ADDENDUM NO.: TWO

DATE OF ADDENDUM: January 24, 2013

**Renovations & Additions to Jenkins-Waggoner Laboratory
CAES, 123 Huntington St, New Haven CT 06511
BI – P – 86**

<p>50 Griffin Road South Bloomfield, CT 06002 Tel: (860) 236-0111 www.bvhs.com</p>	Sketch Title FOUNDATION PLAN Project Title RENOVATIONS and ADDITIONS to JENKINS-WAGGONER LABORATORY		DCS Project Number: BI - P - 86	Sketch Revised
	Sketch Number SKS-013	RFI Number	Reference Sheet S-100

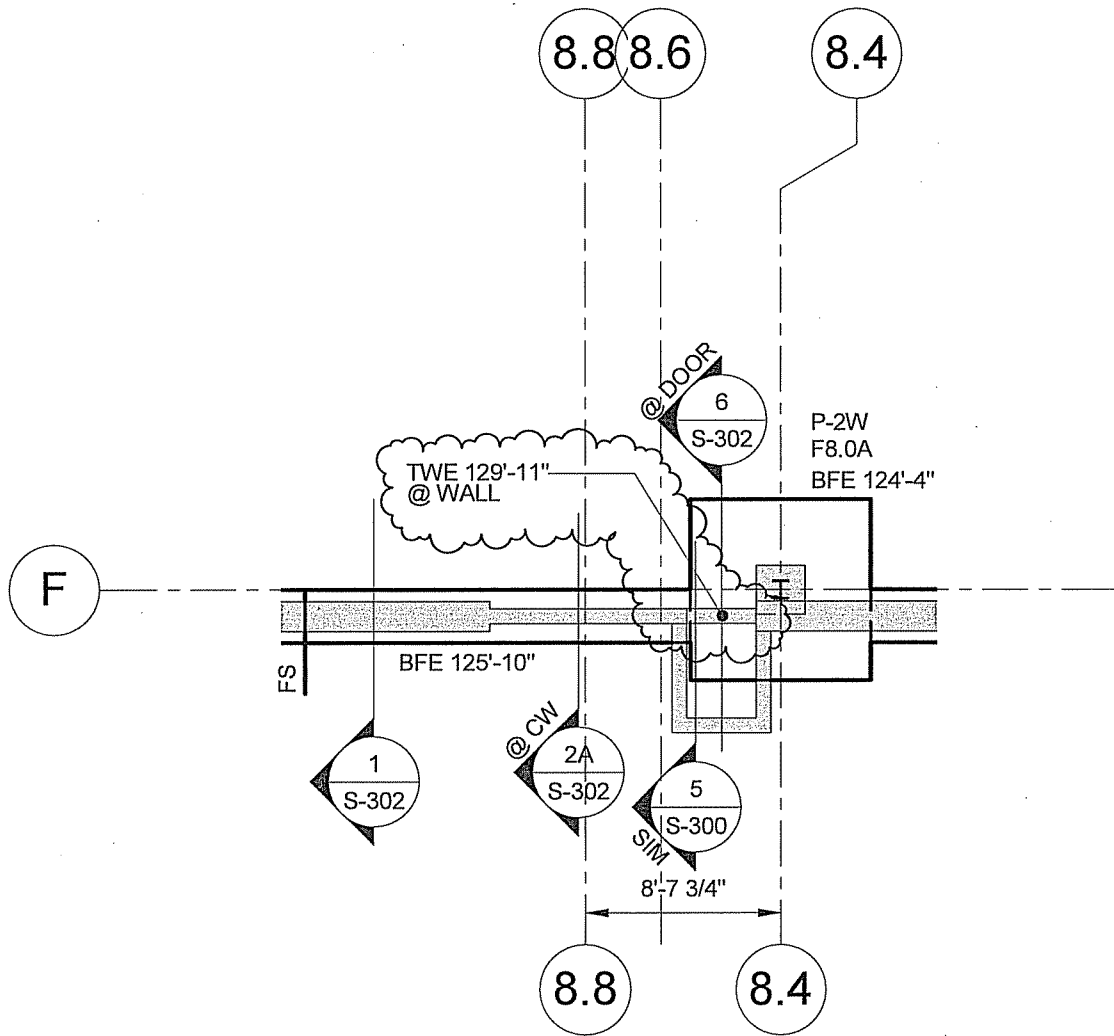
Drawing S-100, Clarified top of wall elevations. Refer to attached Sketch SKS- 013.

Sketch Title FOUNDATION PART PLAN Project Title RENOVATIONS and ADDITIONS to JENKINS-WAGGONER LABORATORY	Reference Sheet S-100	Sketch Issue Date 01/23/13
	RFI Number SKS-015	Revision Number 211115
Sketch Number SKS-015	DCS Project Number: BI - P - 86 BVH Project Number: 211115	Sketch Revised

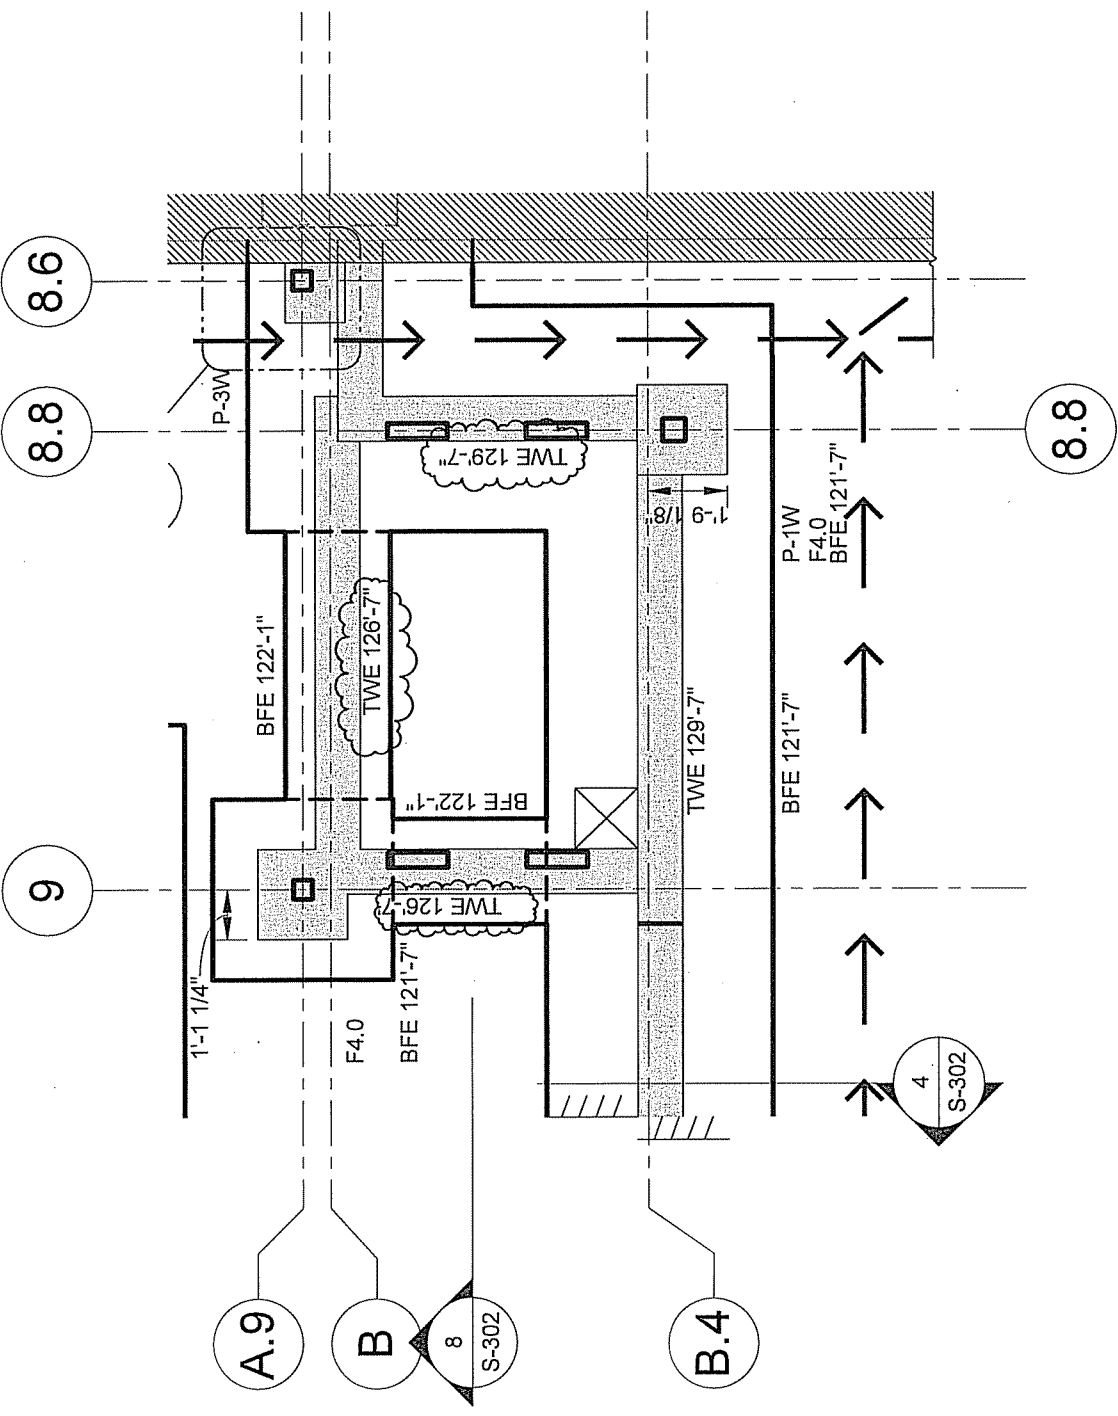
Drawing S-100 - Part Plan A/S-100, Clarified top of wall elevations. Refer to attached Sketch SKS- 015.

<small>50 Griffin Road South Bloomfield, CT 06032 Tel (860) 266-9171 www.bvhs.com</small>	Sketch Title FOUNDATION PLAN Project Title RENOVATIONS and ADDITIONS to JENKINS-WAGGONER LABORATORY		DCS Project Number: BI - P - 86	Sketch Revised
	Sketch Number SKS-016	RFI Number	Reference Sheet S-100

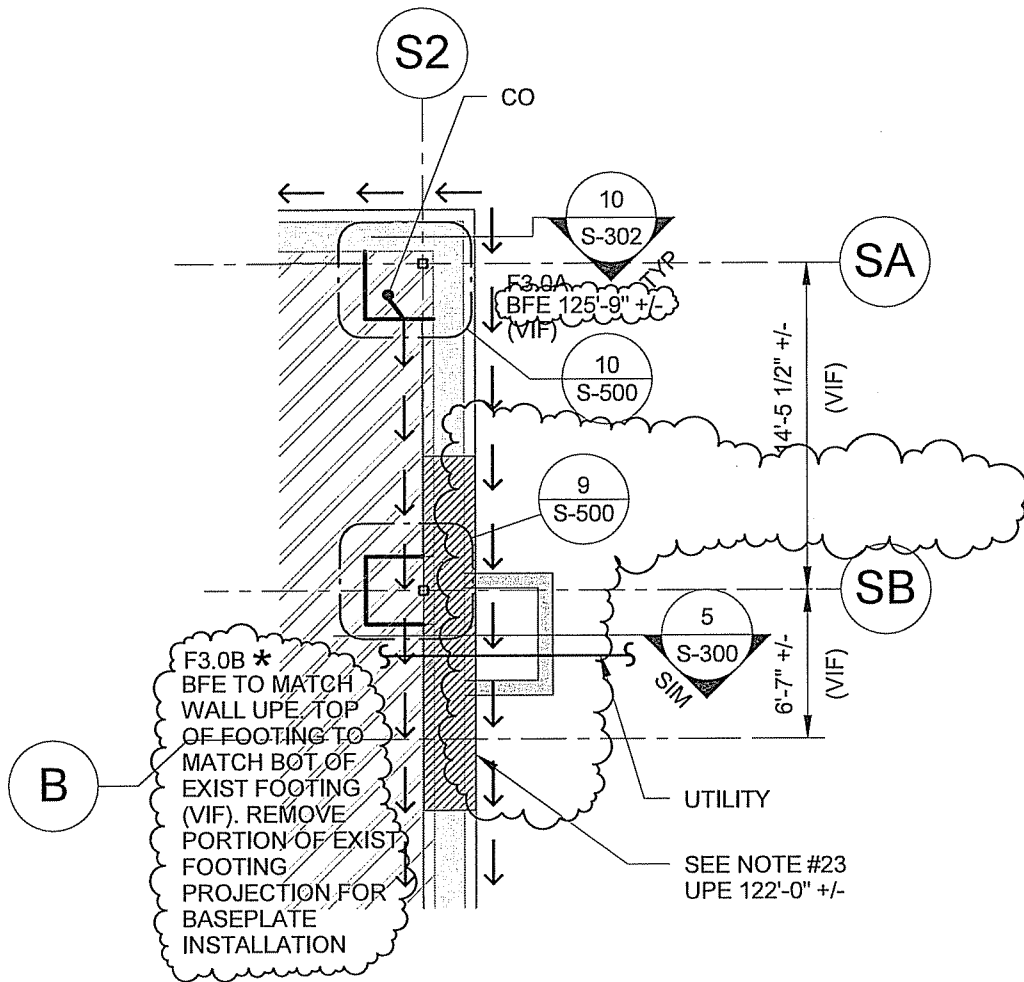
Drawing S-100, Deleted retaining walls and modify BFE's. Refer to attached Sketch SKS- 016.

8 SECTION AT ELEVATOR PIT
S-300 NOT TO SCALE

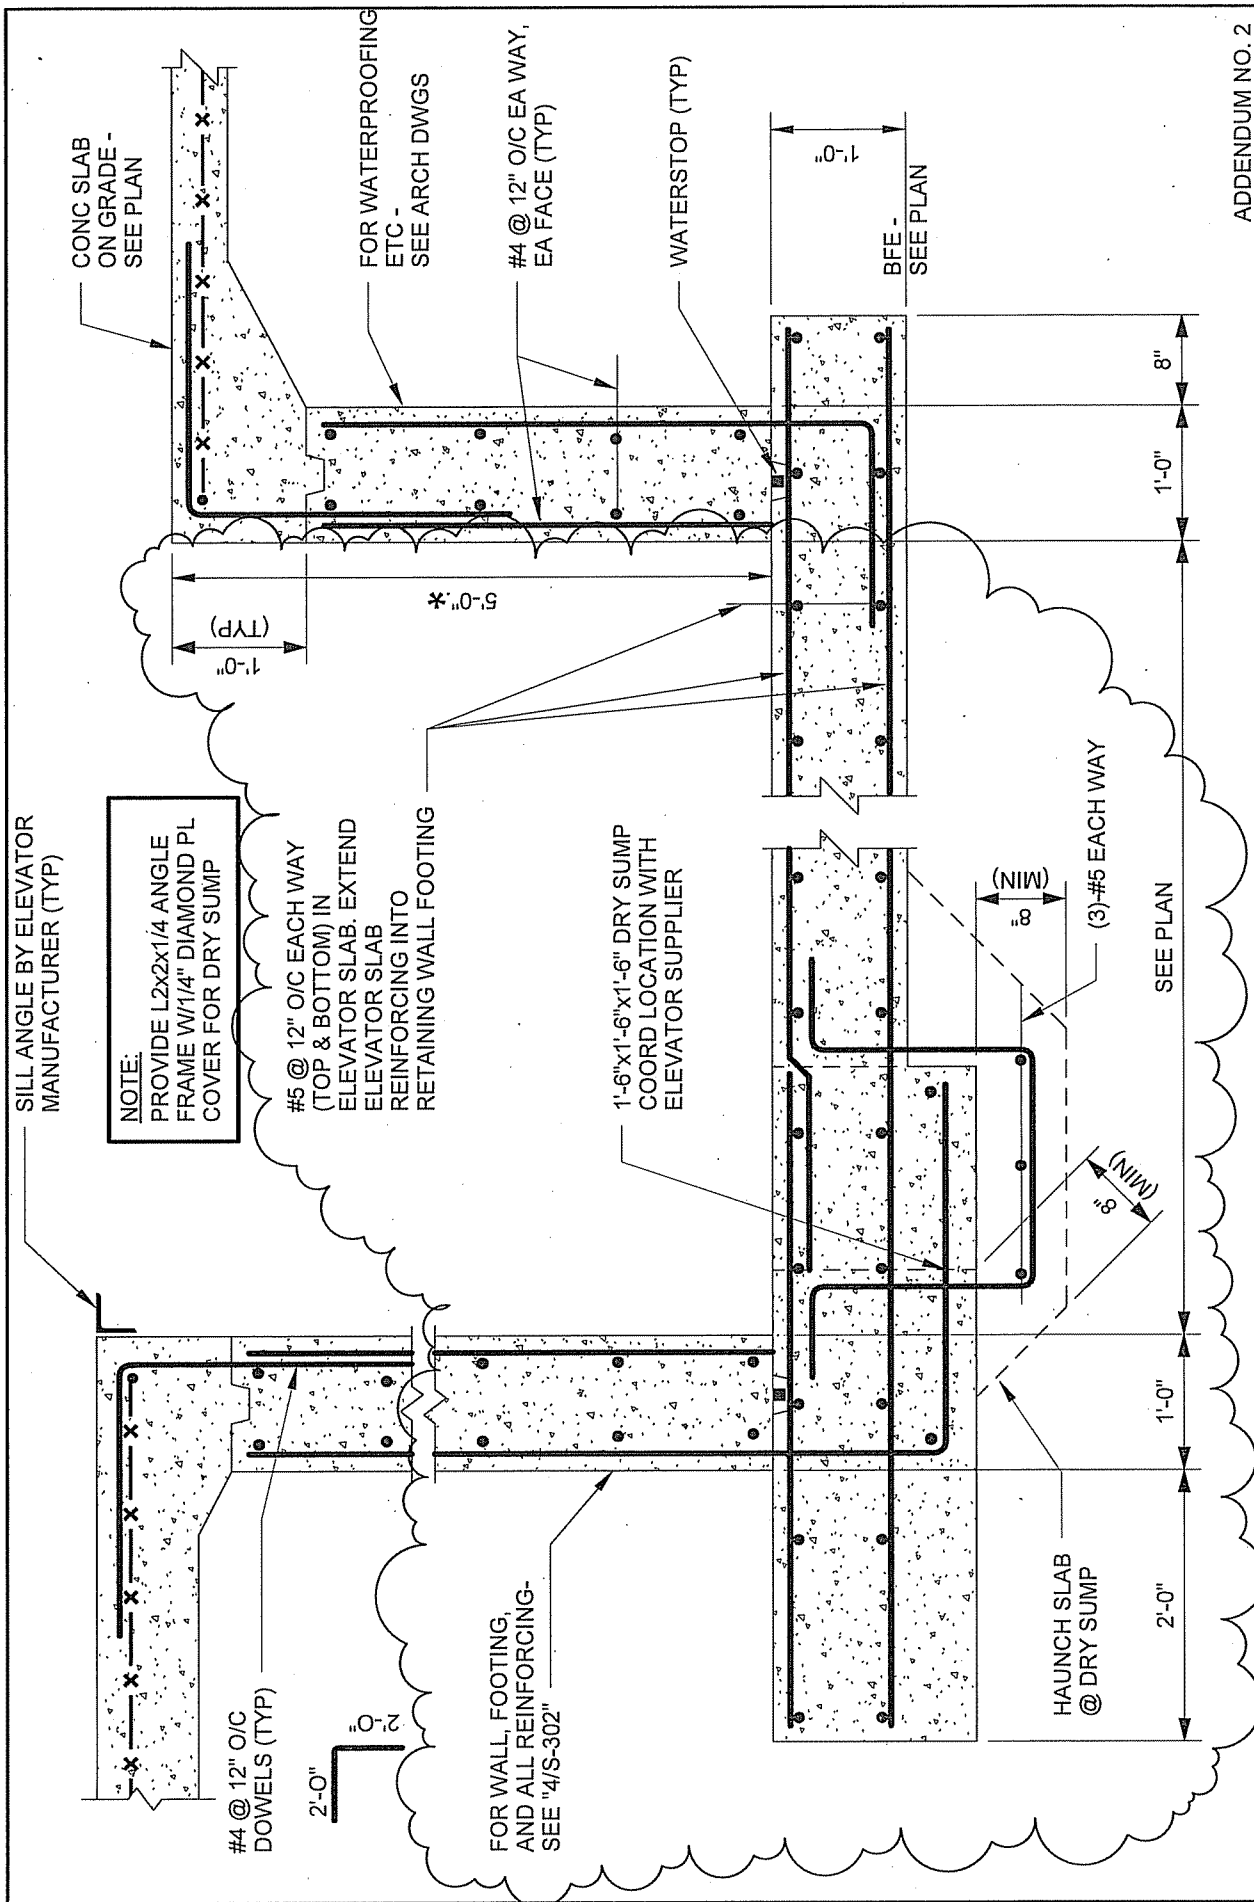
Drawing S-300, Revised section 8/S300. Refer to attached Sketch SKS- 017.

11 FOUNDATION DETAIL

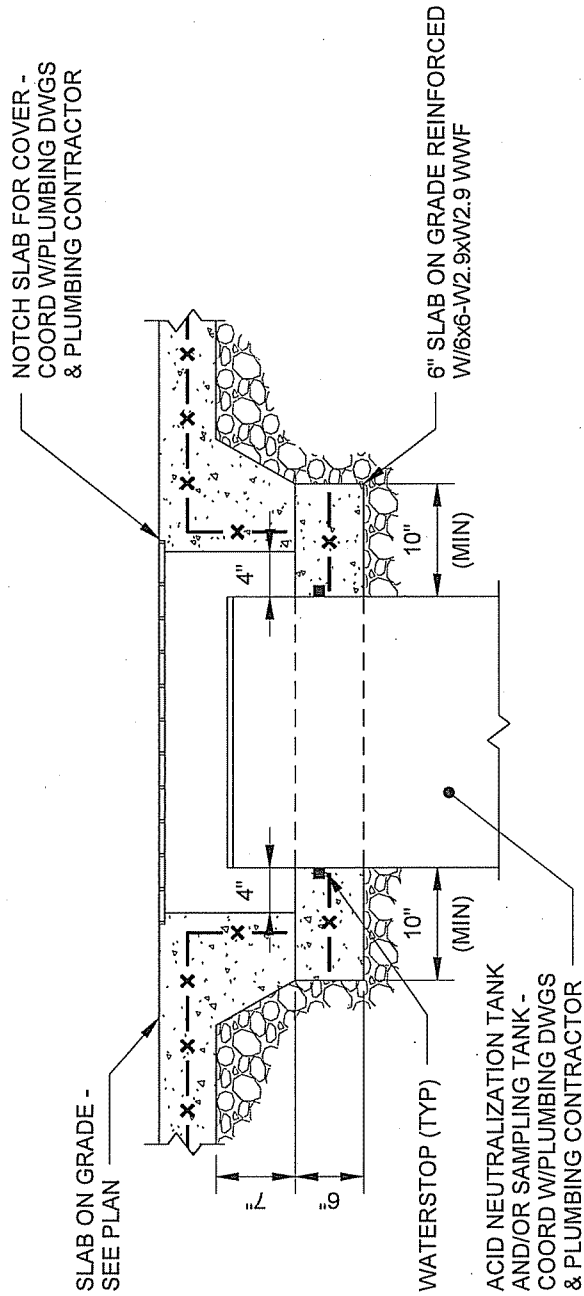
Drawing S-302, Added note to section 11/S302. Refer to attached Sketch SKS- 018.

1. PROVIDE 4'-0"x4'-0"x8" THICK REINFORCED CONCRETE HOLD DOWN PAD BELOW TANK. PAD TO BE NORMAL WEIGHT CONCRETE WITH A 28-DAY COMPRESSIVE STRENGTH OF AT LEAST 3000 PSI. PROVIDE (4)-#4 EACH WAY, TOP AND BOTTOM. COORDINATE LOCATION AND TANK ANCHORAGE REQUIREMENTS WITH MEP CONTRACTOR.

Sketch Title PART - FIRST FLOOR PLAN	DCS Project Number: BI - P - 86	Sketch Revised
	FLAD Project Number: 10844-00	Revision Number
Project Title Renovations & Additions to Jenkins-Waggoner Laboratory	Reference Sheet A-101	Sketch Issue Date 01/23/13
Sketch Number ASK-A101C	RFI Number	Revision Number

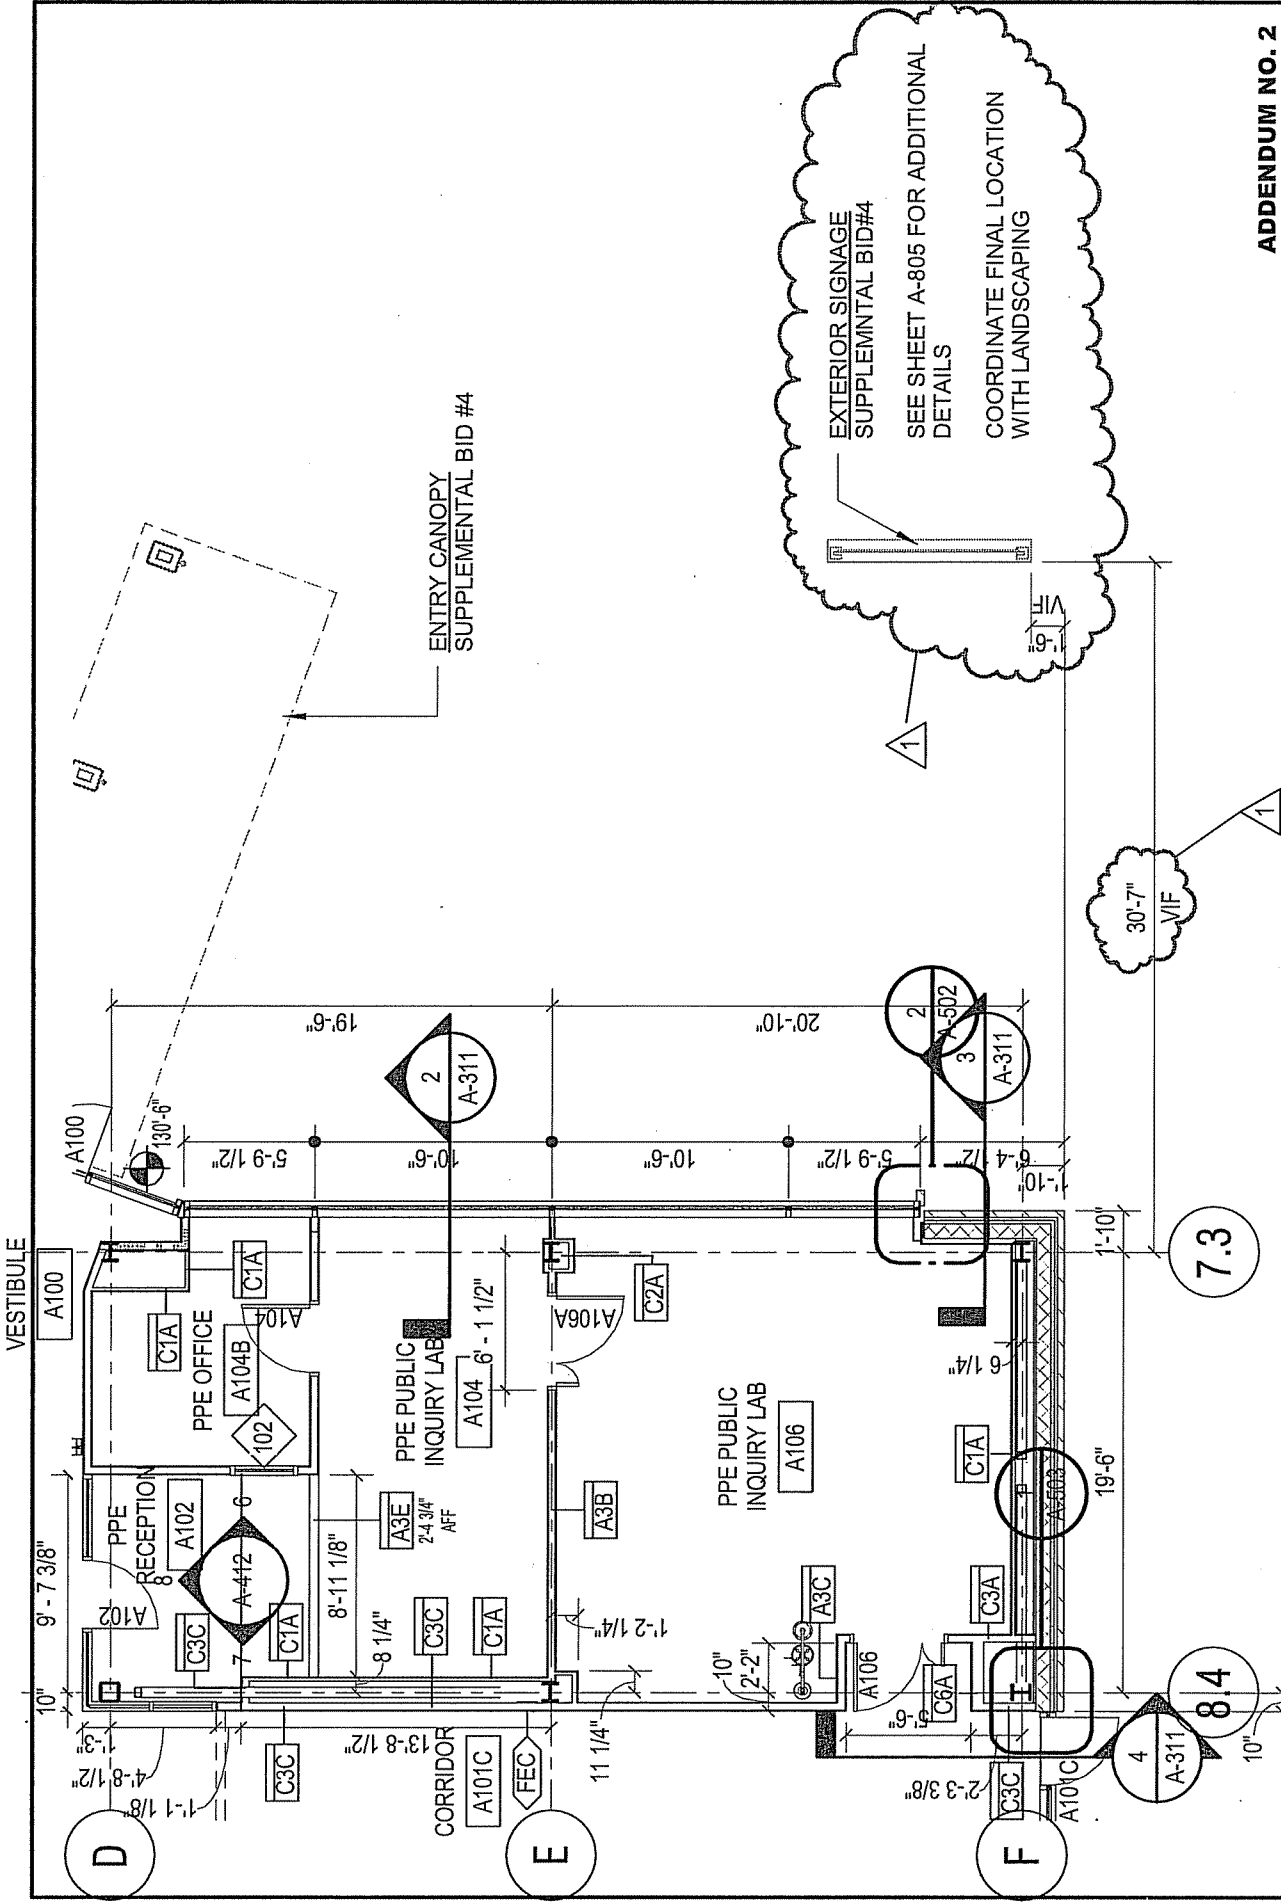
Drawing A-101. Exterior Sign included in Addendum One is located on plan and Corner Guards locations have been noted. Refer to attached sketch ASK-A101c, ASK-A101d, ASK-A101e and ASK-A101f.

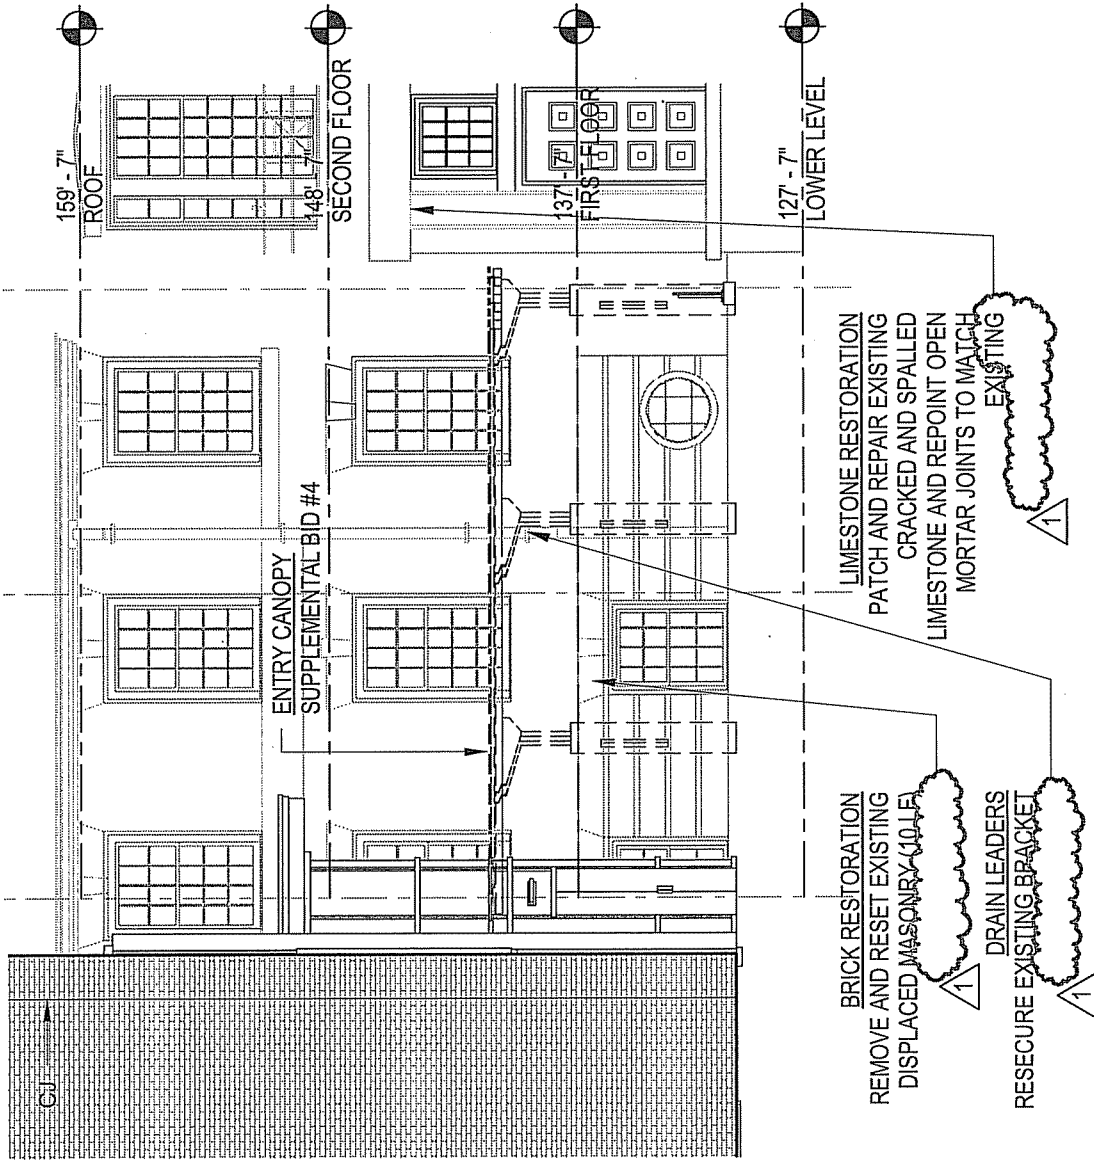
Drawing A-201. Reference to photos has been deleted. Refer to attached sketch ASK-A201a and ASK A201b.
